Sairam (Holdings) Limited

Brockley Hill, Stanmore - New Banqueting Facility

Supplementary Design and Access Statement

West Elevation

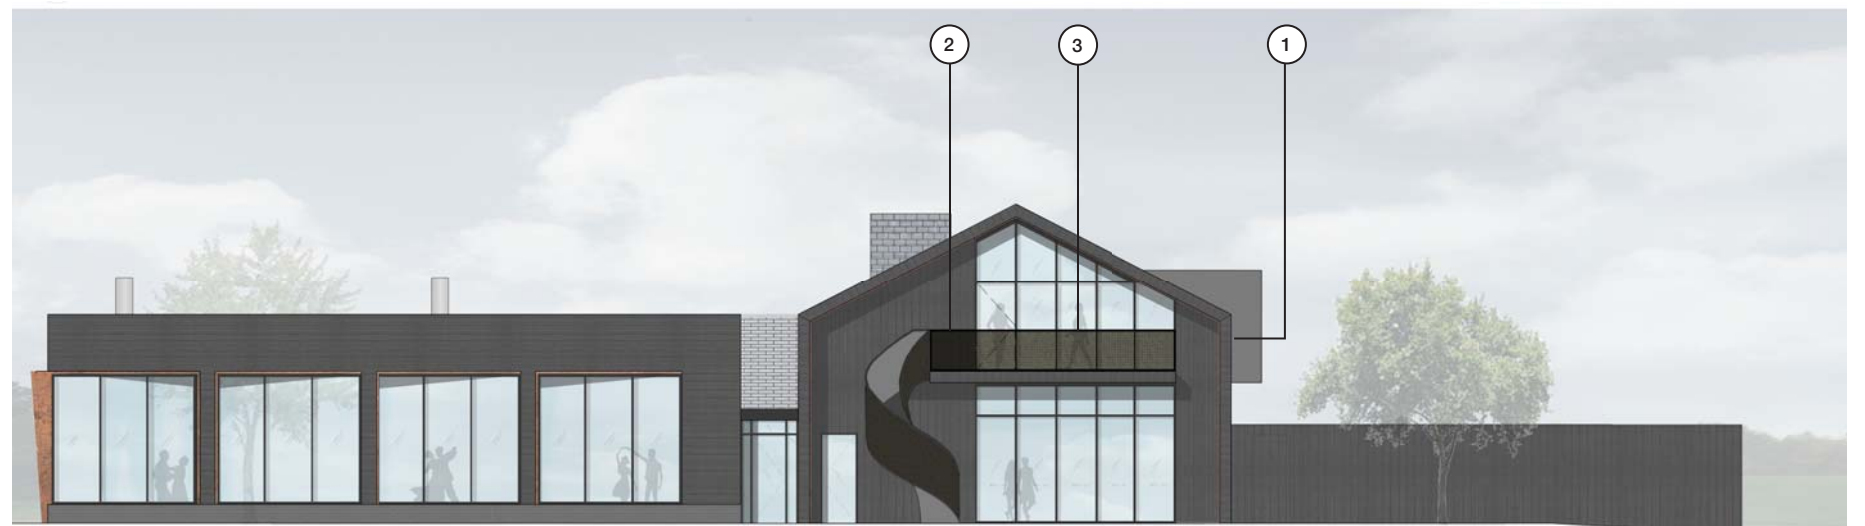
The gable end of the Front of House building has been brought down to ground, emphasizing the barn typology.

1. Introduction of a wall to close off the gable end of the Front of House building.
2. Wraparound balcony split into two separate balconies on the west and south elevations.
3. Reduced extent and change of the laser cut material.

North Elevation

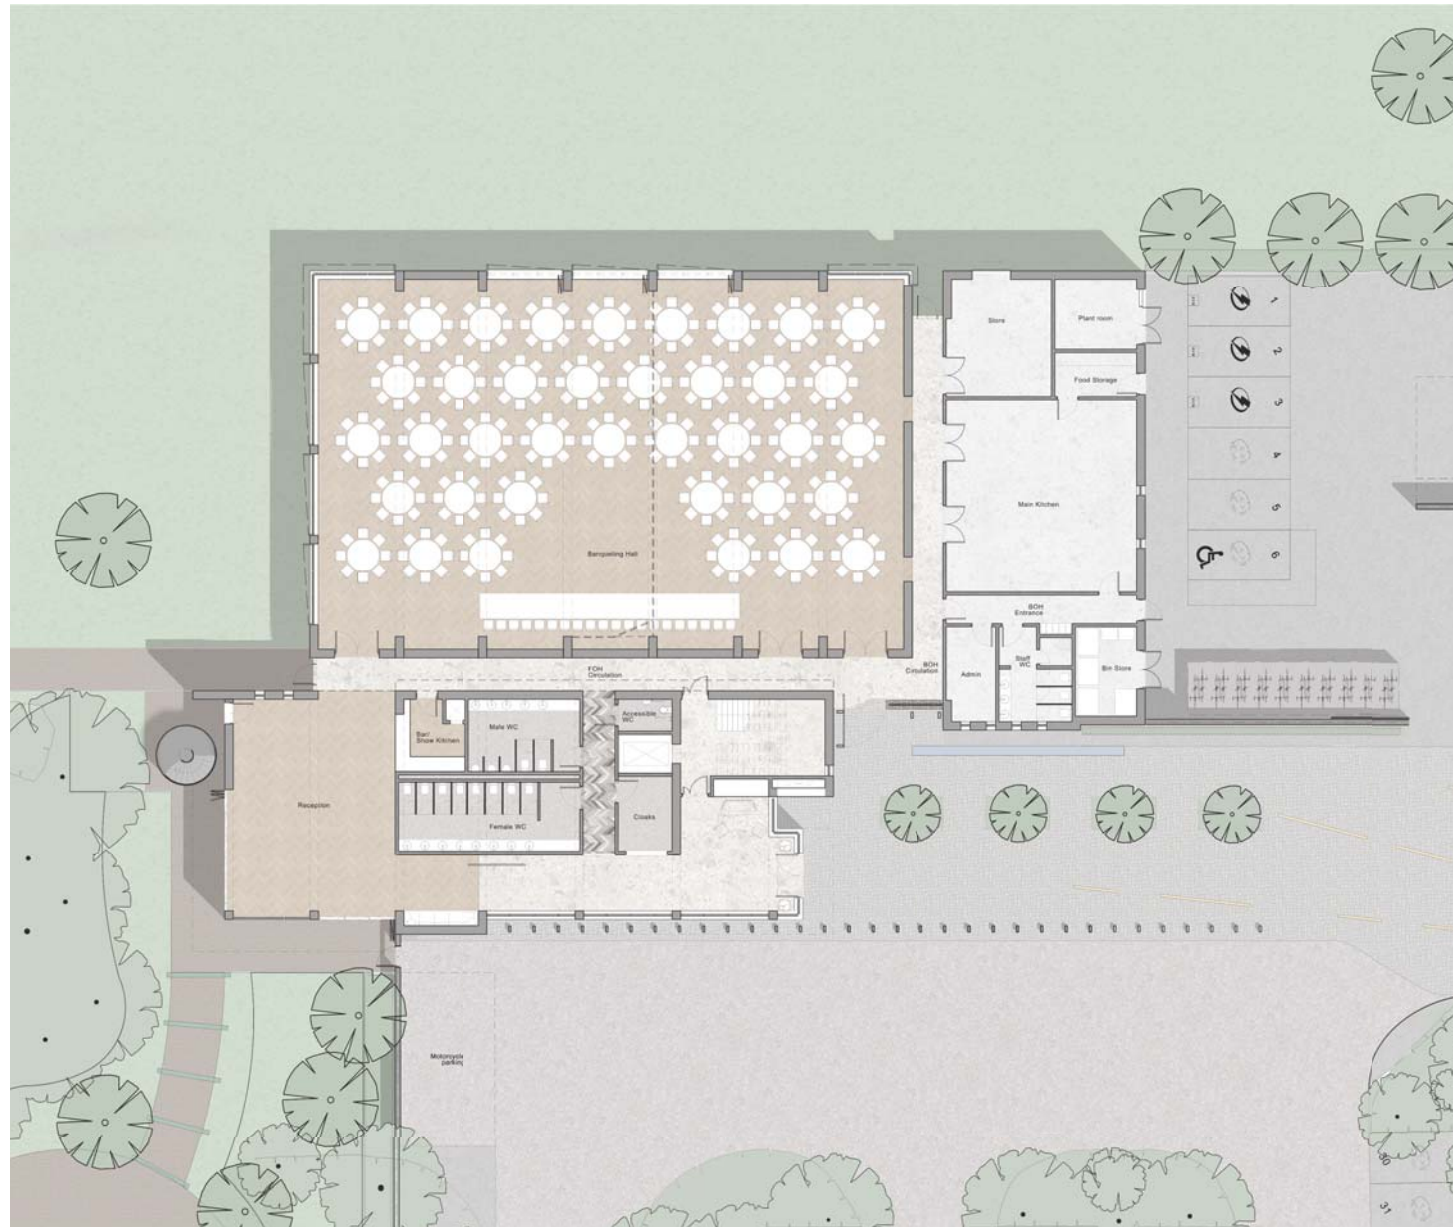
The north elevation has been graphically edited to emphasize the north facing banqueting hall elevation and to ensure that the Front of House building is set back and read as a different plane.

- 1. Graphical edit to elevation to emphasize the different planes.
- 2. Change of the laser cut material.

Ground Floor Plan

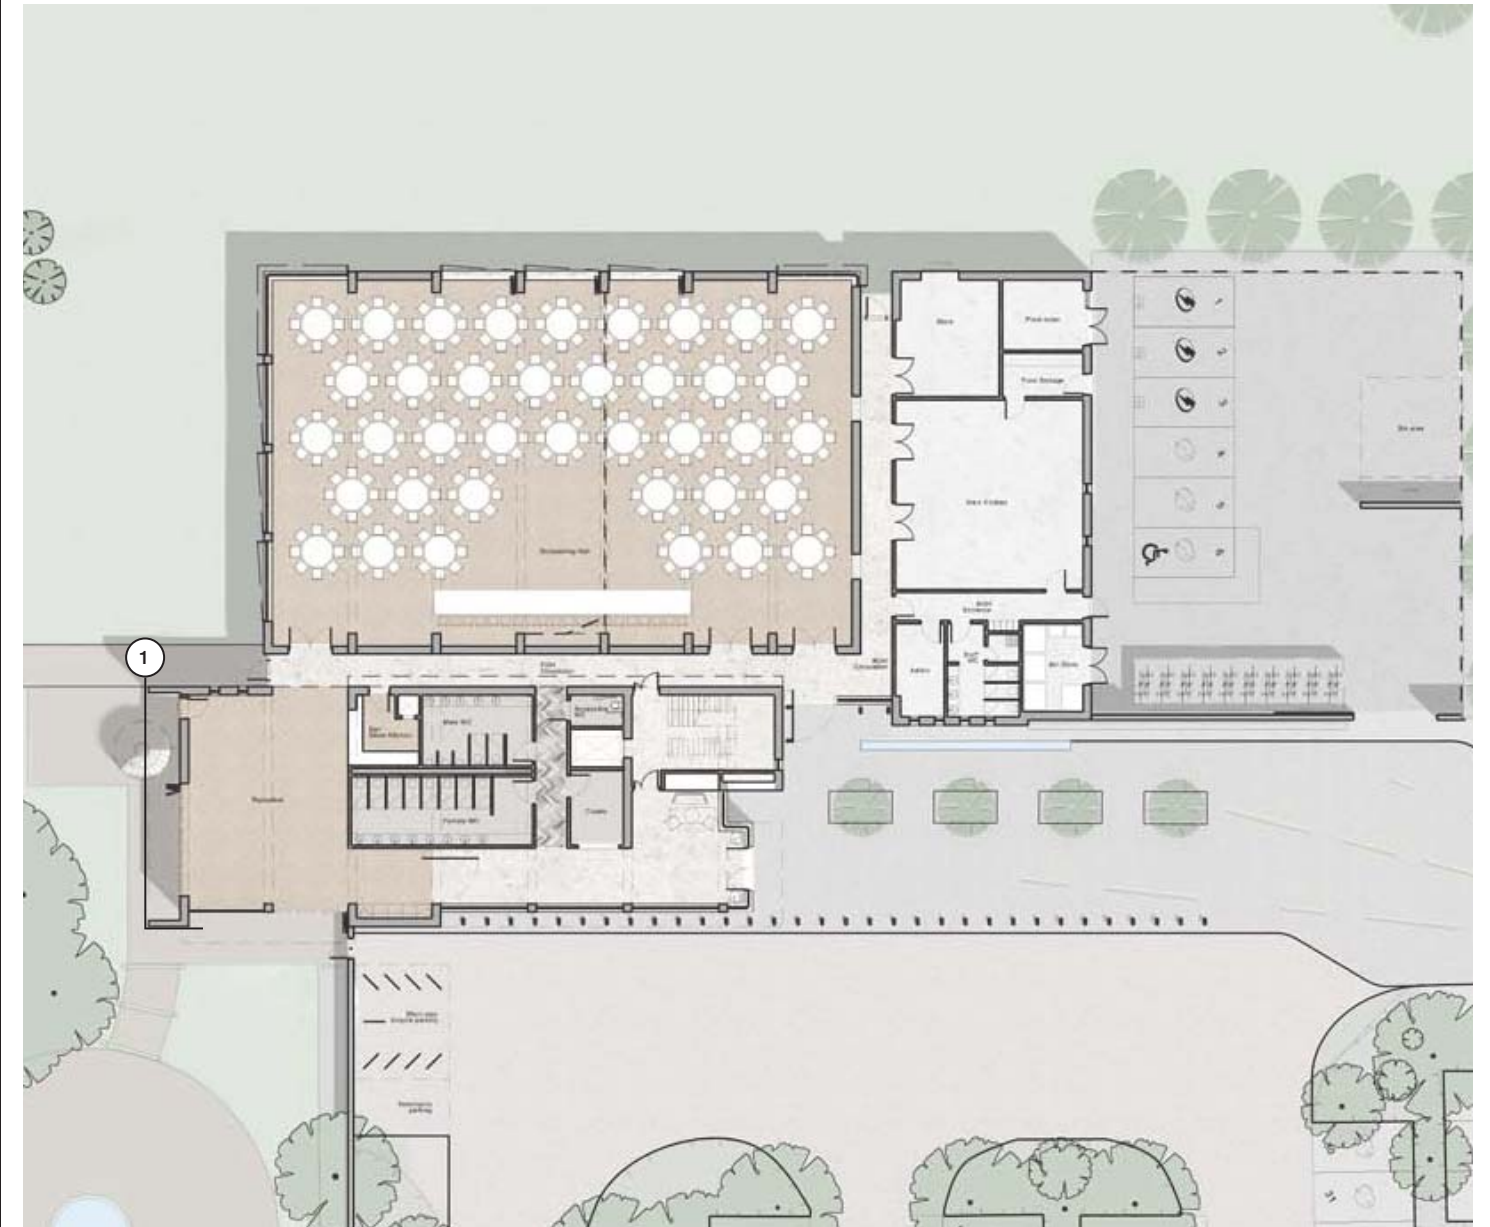
The gable end of the Front of House building has been brought down to ground, emphasizing the barn typology.

This has simplified the structure and hasn't affected the internal area of the proposal.

- 1. Introduction of a wall to close off the gable end of the Front of House building.

First Floor Plan

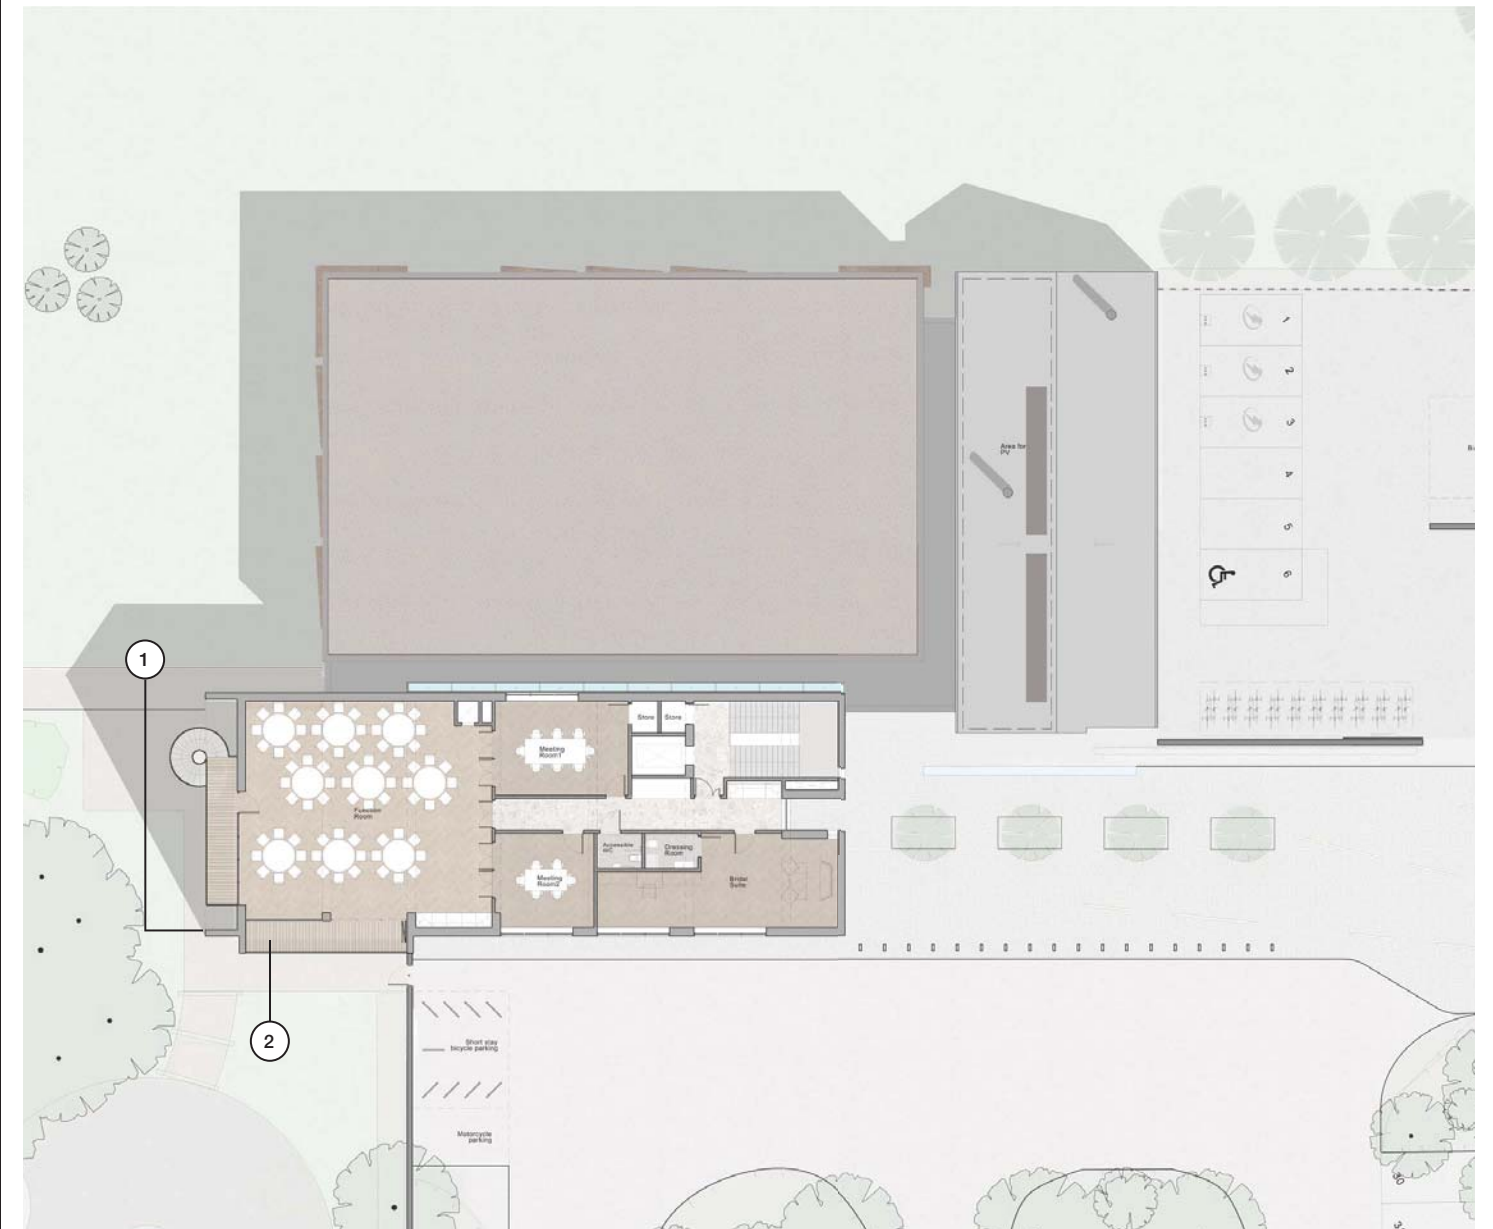
The wraparound balcony has been split into two separate balconies on the west and south elevations of the Front of House building.

This hasn't affected the internal area of the proposal.

1. Introduction of a wall to close off the gable end of the Front of House building.
2. Wraparound balcony split into two separate balconies on the west and south elevations.

3.7 Response to Statutory Consultees Roof Plan

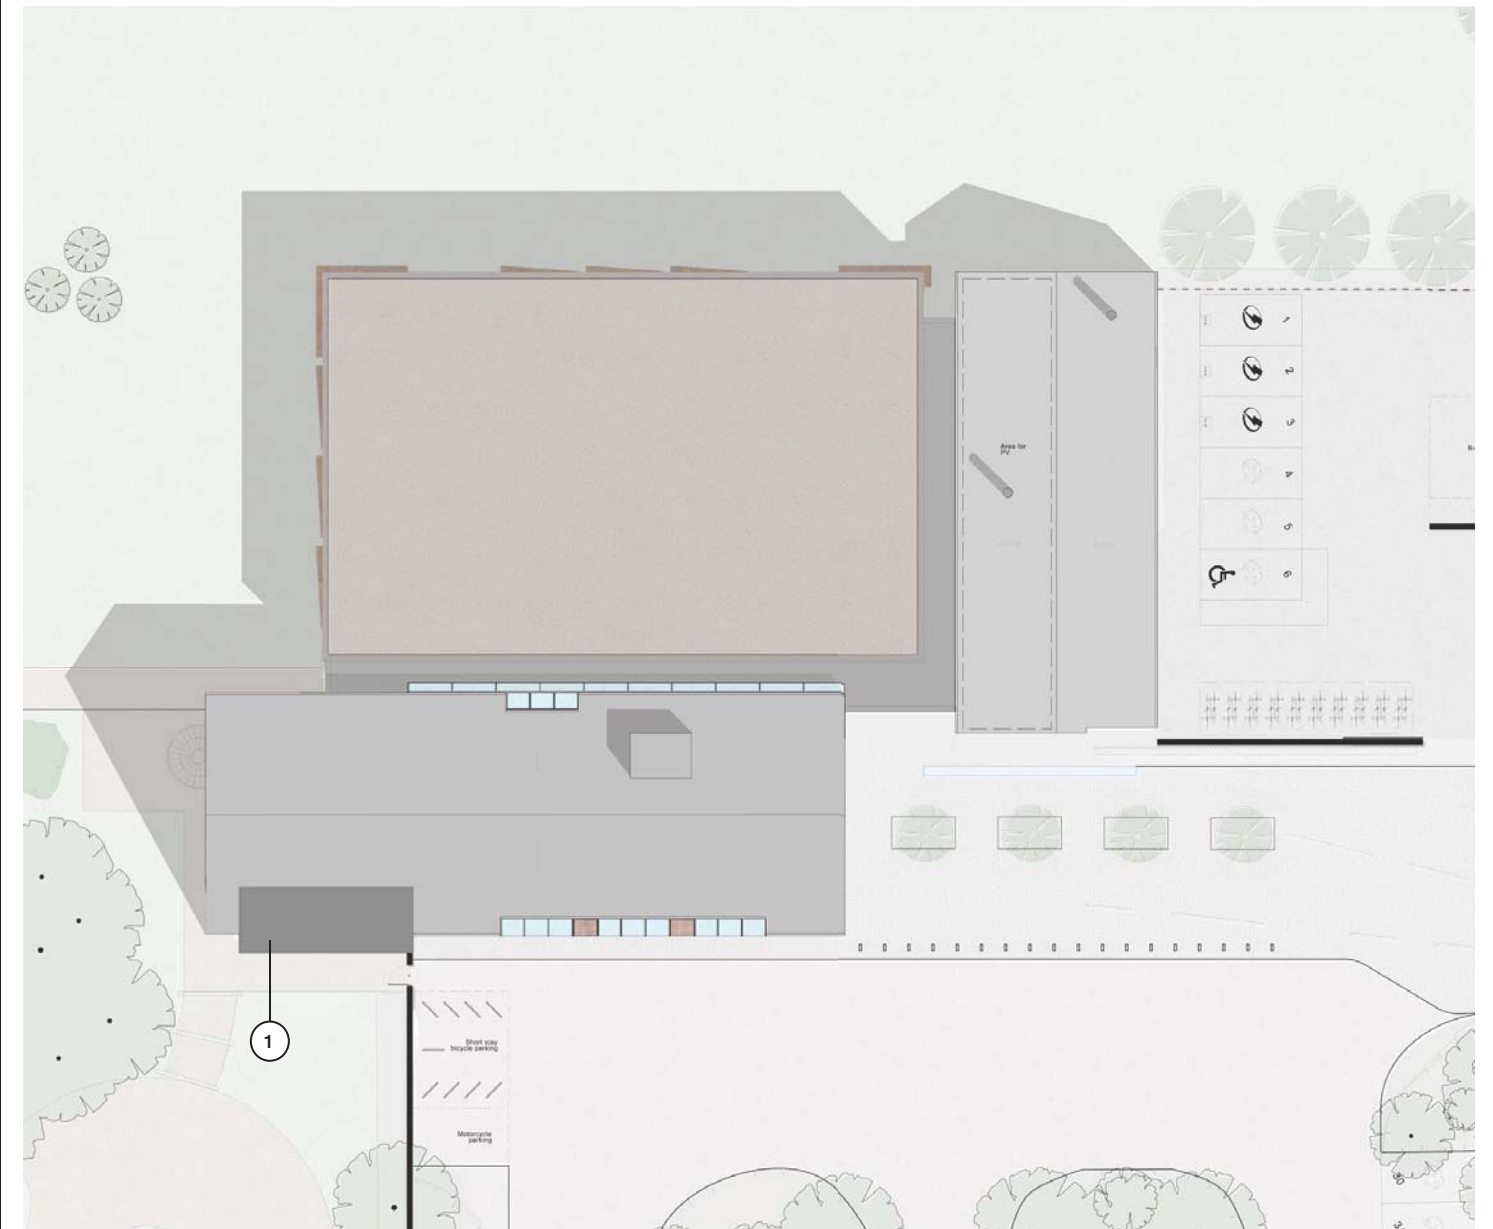
The gable end of the Front of House building has been brought down to ground, emphasizing the barn typology.

1. Wraparound balcony replaced with a dormer type projecting balcony.
